UNITED STATES PATENT AND TRADEMARK OFFICE

Office Action Summary

10/750,698

DETAILED ACTION

Diagram A - Annotated Figure 3 of Jost

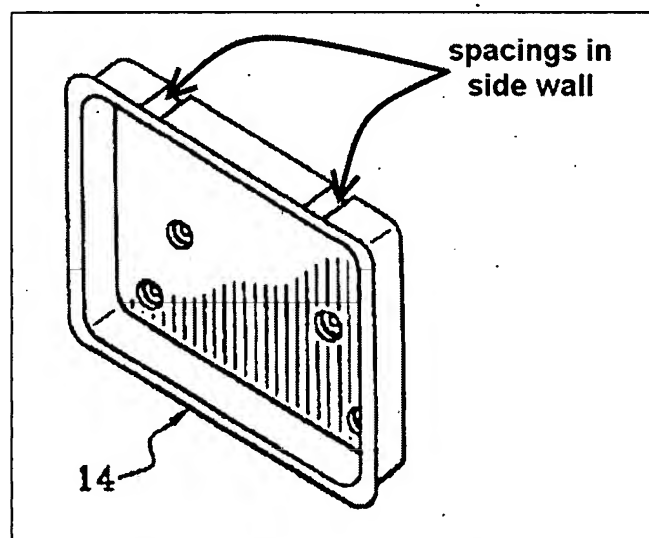
one of the post is adjustable to modify the distance between the post, and at least one post is capable of vertical pivoting about an axis formed along sleeve 19. See Diagram A below showing that at least one of the plurality of side walls of Jost is noncontinuous and by portions of the front wall being removed the overall height of the wall is reduced.
